# UNITED STATES PATENT AND TRADEMARK OFFICE

APPLICATION NO.	FILING DATE	FIRST NAMED INVENTOR	ATTORNEY DOCKET NO.	CONFIRMATION NO	
10/673,274	09/30/2003	Hui Ling Chen	3098/115	4747	
23338 75	590 08/11/2004		EXAM	EXAMINER	
	SCHULTZ, DOUGHE	THOMAS, DAVID B			
1727 KING ST	REET		· · ·		
SUITE 105			ART UNIT	PAPER NUMBER	
ALEXANDRIA	A, VA 22314		3723		
			DATE MAIL ED: 08/11/2004	4

71				
		Application No.	Applicant(s)	7				
Office Action Summary		10/673,274	CHEN, HUI LING	Y				
		Examiner	Art Unit					
		David B. Thomas	3723					
Period fo	The MAILING DATE of this communication app r Reply	pears on the cover sheet wi	th the correspondence address	; ·				
THE N - Exten after S - If the - If NO - Failur Any re	DRTENED STATUTORY PERIOD FOR REPLINATION.  MAILING DATE OF THIS COMMUNICATION.  Isions of time may be available under the provisions of 37 CFR 1.1  SIX (6) MONTHS from the mailing date of this communication.  period for reply specified above is less than thirty (30) days, a replination of the provision of the p	36(a). In no event, however, may a rely within the statutory minimum of thirt will apply and will expire SIX (6) MON e, cause the application to become AB	eply be timely f

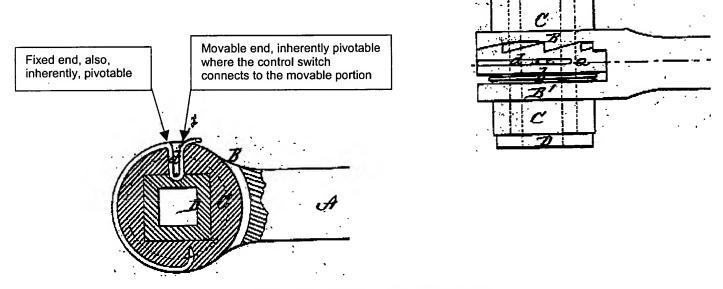
Fogel ('594) discloses a wrench capable of clamping a screwed member and releasing the screwed member, the wrench having a stem having a head section at one end of the stem; a polygonal socket having multiple inner angles for fitting the screwed member; a substantially C-shaped resilient spring having two ends, the resilient ring being resiliently closable and openable between closed state and an expanded state to change the diameter of the resilient

Movable end, inherently pivotable where the control switch connects to the movable portion

Fixed end, also, inherently, pivotable

the socket, one end of the resilient ring being a fixed end pivotally

disposed at the head section, while the other end of the resilient ring
